TECHNICAL SERVICE BULLETIN 10043

MODEL(S): 150GTL, 200GTL

DESCRIPTION: Receiver overloads when receiving a strong signal, resulting in distorted audio. In addition there may be a warble in the modulation when transmitting (which the customer might describe as a popping sound during transmit).

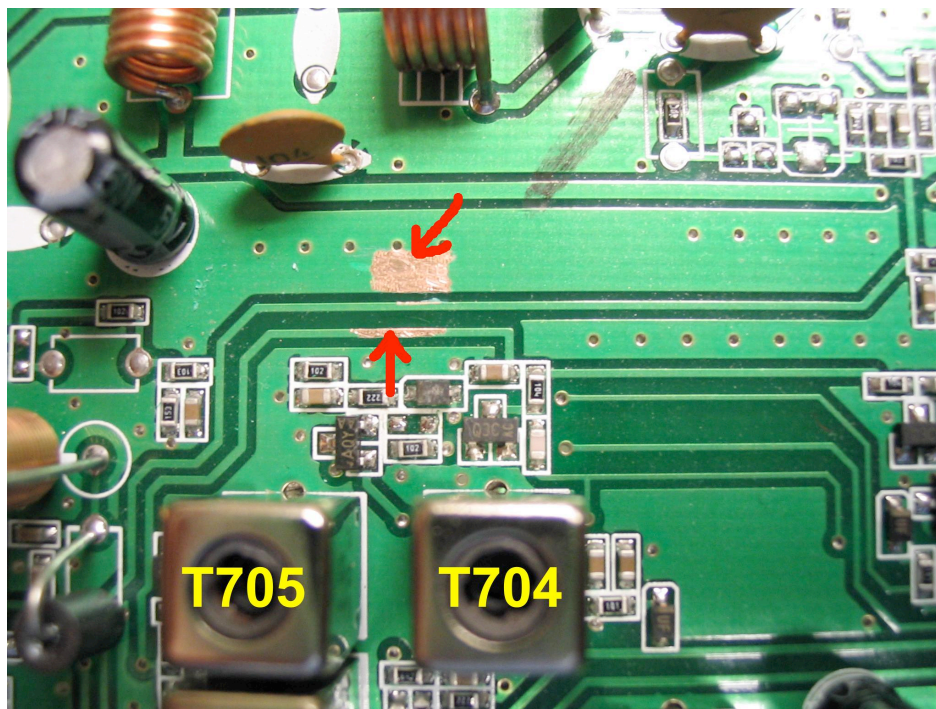
ACTION: RF is bleeding into the receiver front-end. Apply the following fix:

For both the 150GTL and 200GTL, install a 1 μ F electrolytic capacitor across C607. (From C607 to ground)
